LaSalle County Station, Units 1 and 2
Facility Operating License Nos. NPF-11 and NPF-18
NRC Docket Nos. 50-373 and 50-374

Subject: First Six-Month Status Report in Response to March 12, 2012 Commission Order Modifying Licenses with Regard to Requirements for Mitigation Strategies for Beyond-Design-Basis External Events (Order Number EA-12-049)

**First Six-Month Status Report for the Implementation of Order EA-12-049, Order
Modifying Licenses with Regard to Requirements for Mitigation Strategies for Beyond-
Design-Basis External Events**

1. FLEX Simplified Design Electrical Schematic
2. NSSS Significant Reference Analysis Deviation Table

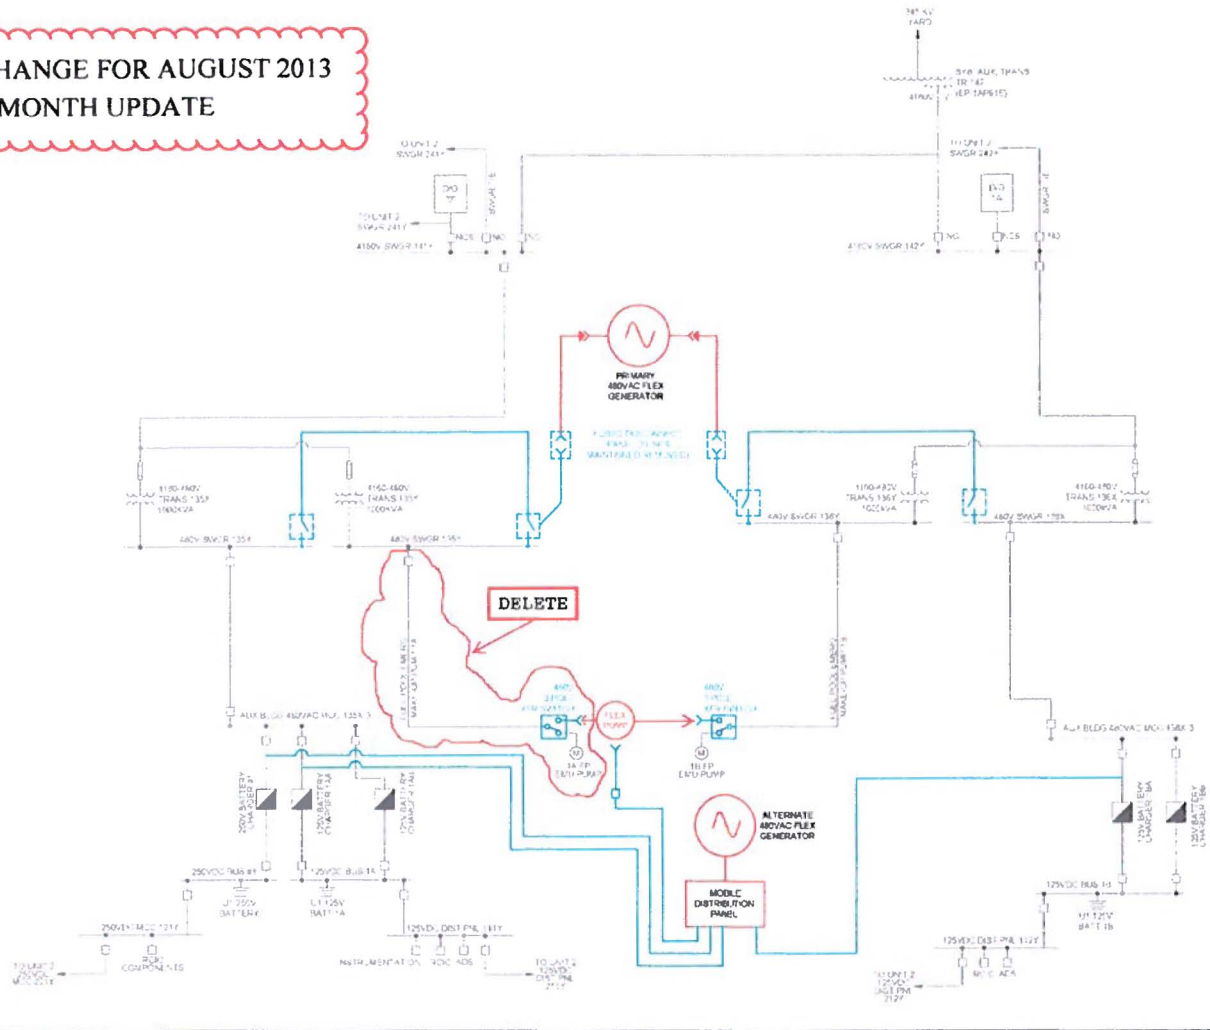
Attachment 3 of Reference 1 contained conceptual sketches of the water supply and electrical power supply strategies. On the electrical sketch, a power supply route from 480V SWGR 135Y was shown to the pre-staged FLEX pump. After further evaluation, it has been determined that this power supply route is not required since the pre-staged FLEX pump will have one power supply path through 480V SWGR 136Y (Primary Strategy) and another possible power supply route directly from the 480VAC FLEX Generator via the Mobile Distribution Panel (Alternate Strategy). The conceptual electrical power supply sketch has been marked up to show the deletion of the power supply path from 480V SWGR 135Y and is attached (Attachment 1).

CHANGE FOR AUGUST 2013
6-MONTH UPDATE
